Addendum 02

Date: 05-21-2026
Project: 22011 – Spin Lofts
 521 21st Ave
 Council Bluffs, IA

Spin Lofts
TD2#: 748-886
Addendum 2
05/15/2026

STRUCTURAL SECTIONS

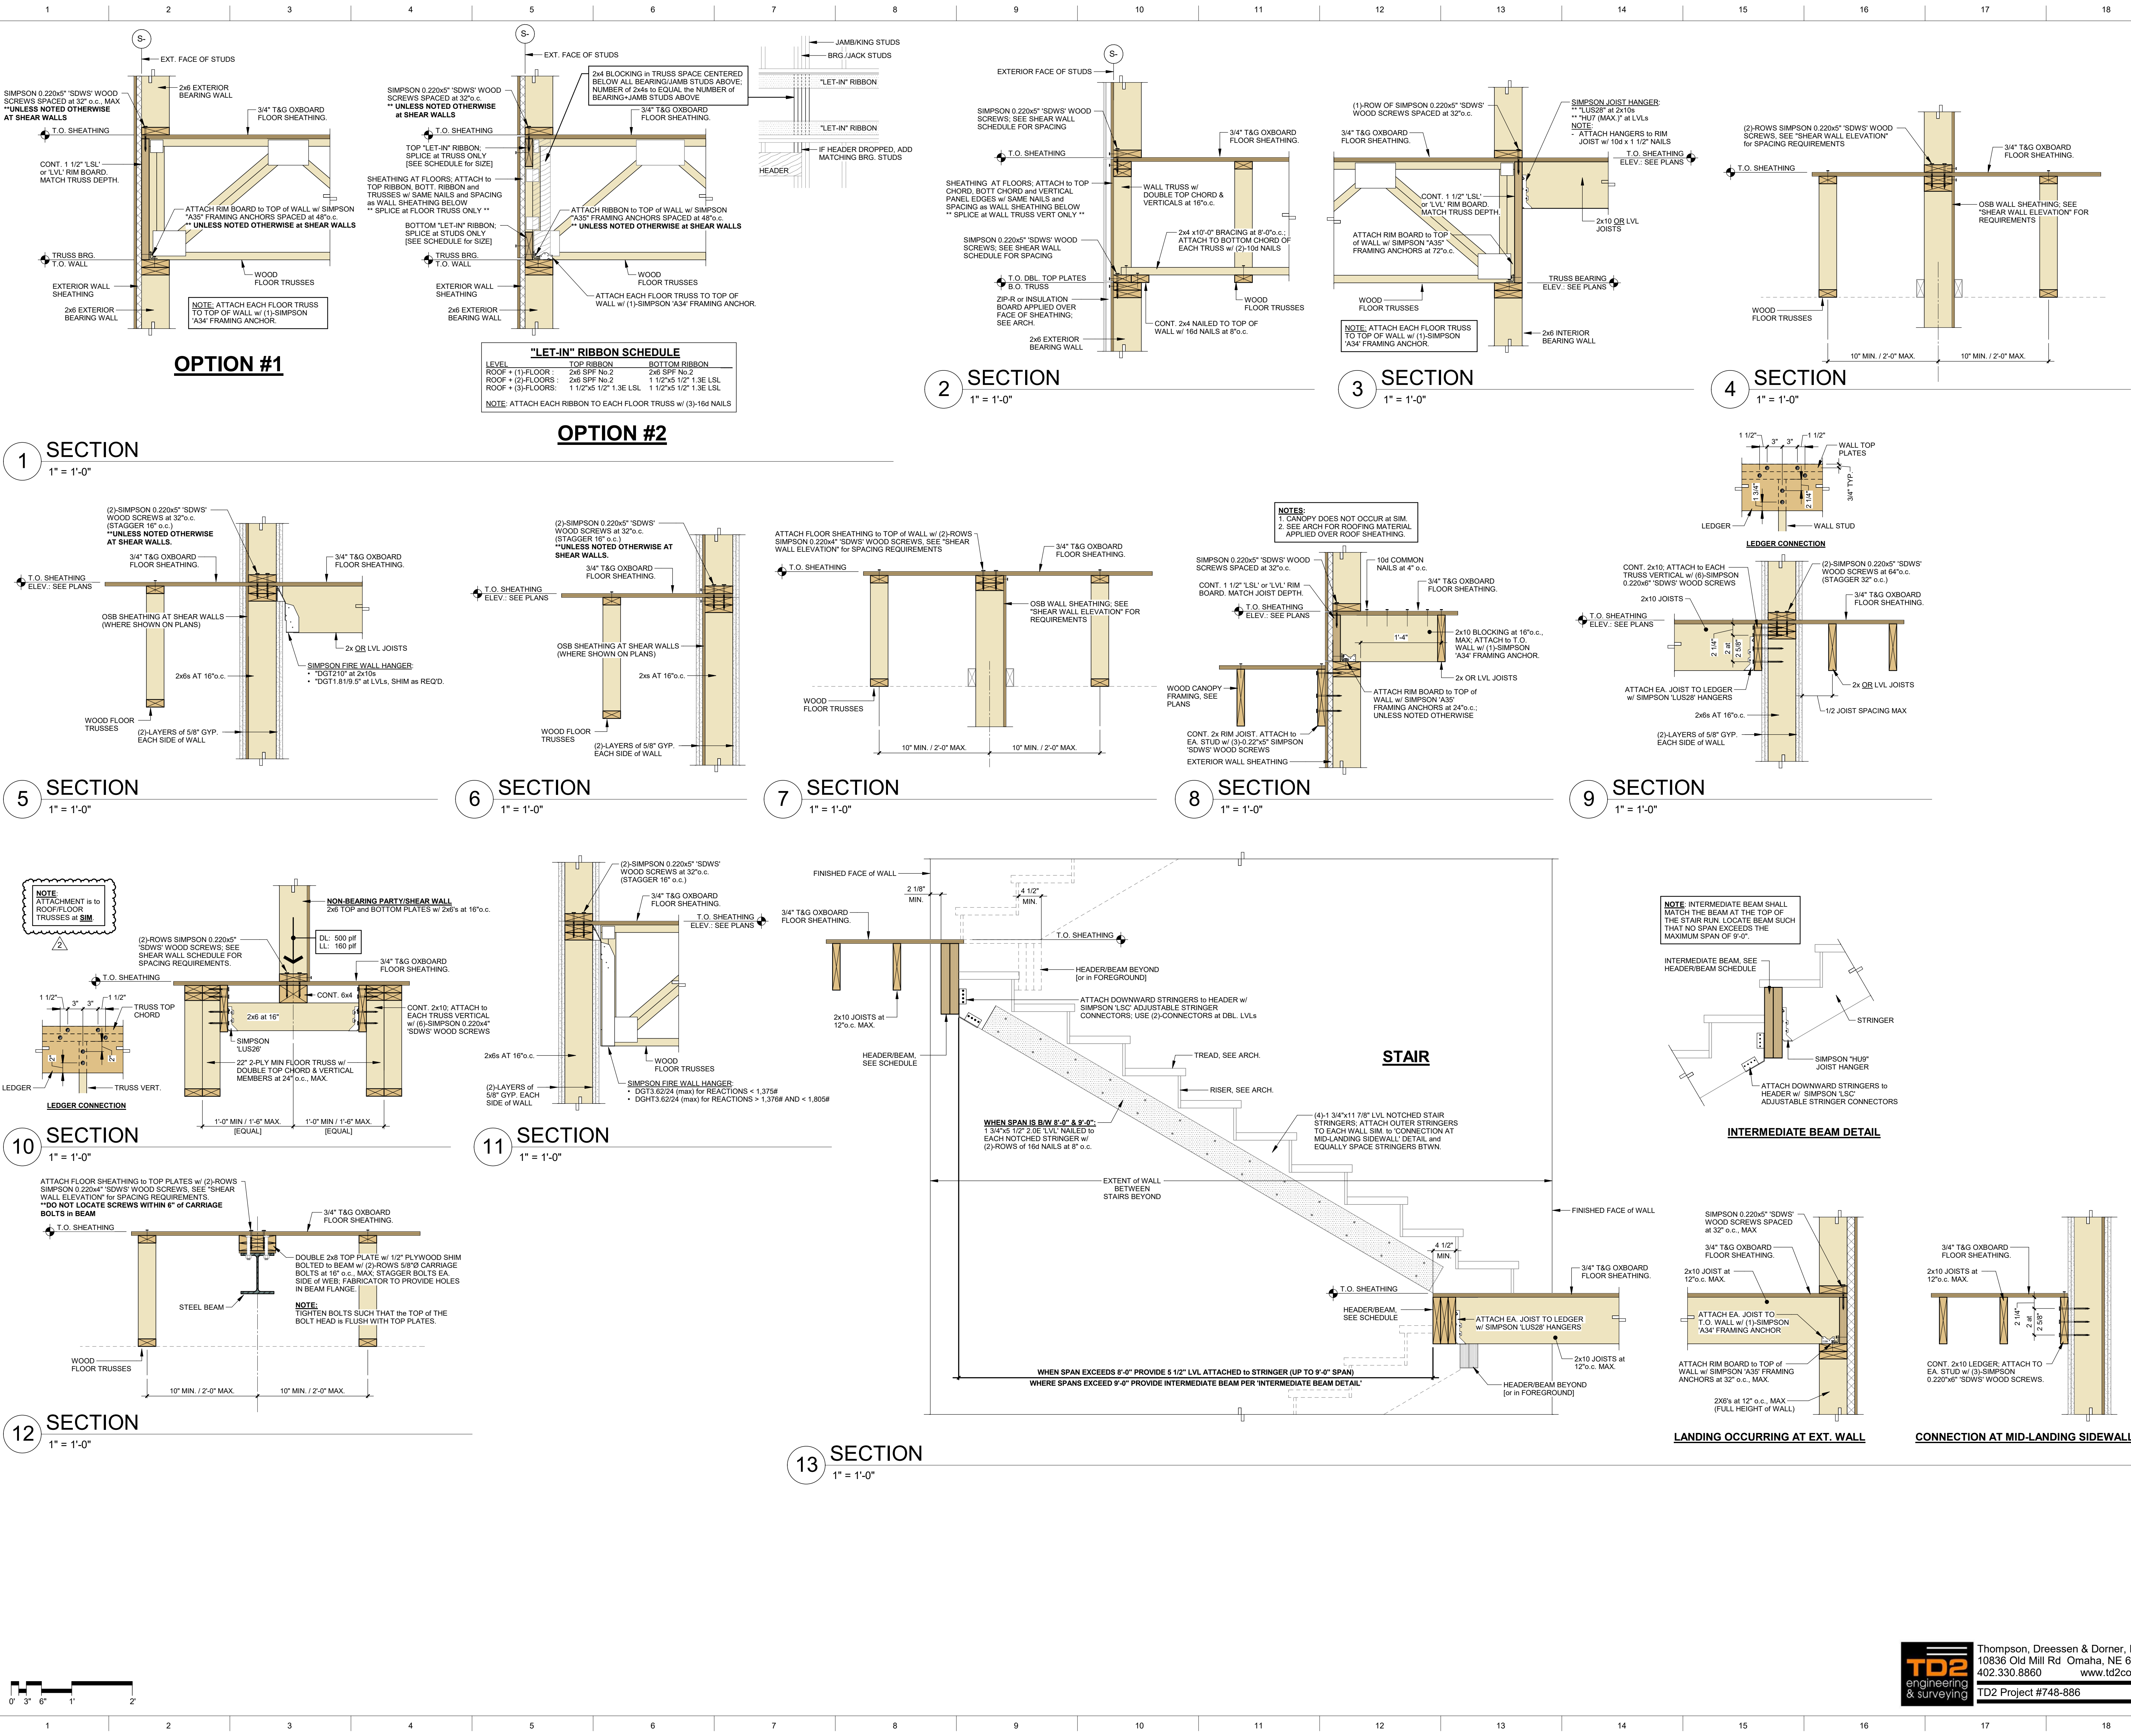
- A. **Detail 10:** Add note about attachment of 2x10 ledgers being to roof/floor trusses at "SIM." (see full-size drawings).
